Completion Checklist for CWRE Claims of Beneficial Use

Application # 15-12261

CLAIM OF BENEFICIAL USE

APPLICATION R-72269

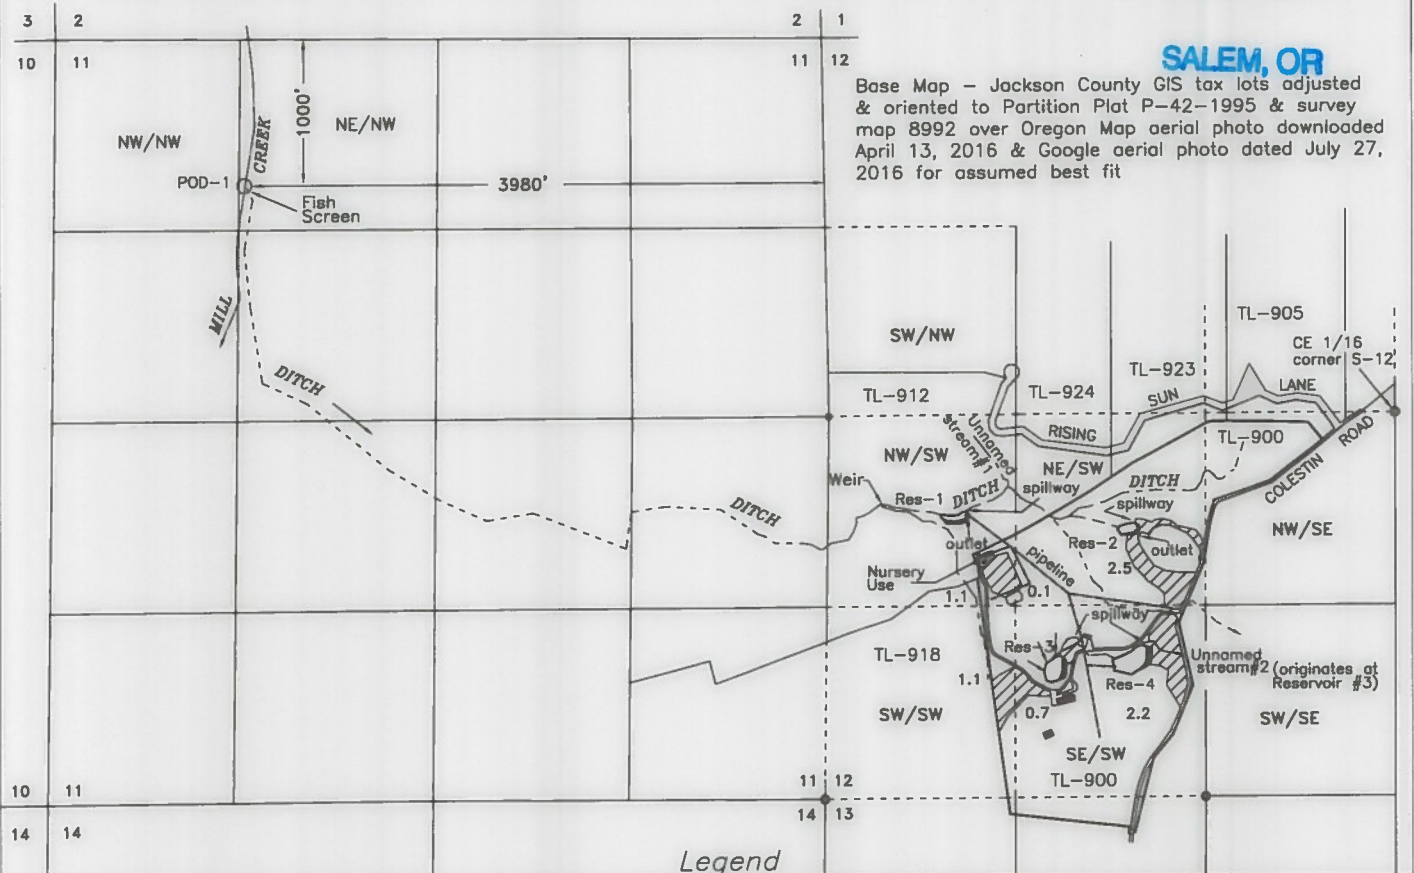
- ☒ Township, range, section, and tax lot numbers (OAR 690-310-0050(4))
- ☐ Source illustrated if surface water (OAR 690-014-0170(3))
- ☐ Point(s) of diversion or appropriation (illustrated) (OAR 690-014(4) & 690-310-0050)

- ☐ Point(s) of diversion or appropriation (coordinates)(OAR 690-014(4) & 690-310-0050)
- ☐ Conveyance structures illustrated (pump, pipelines, ditches, etc.) (OAR 690-310-0050)

- ☐ Description of the location, in relation to the point of diversion or appropriation, of any fish screens, by-pass devices, and measuring devices required (OAR 690-014(4))

- ☐ Place of use (1/4 1/4, or projected 1/4 1/4 lines within DLCs, or Gov Lots; if irrigation, # of acres in each subdivision; if for domestic or human consumption, location of dwelling or spigot) (OAR 690-310-0050, 690-014, 690-380-6010)
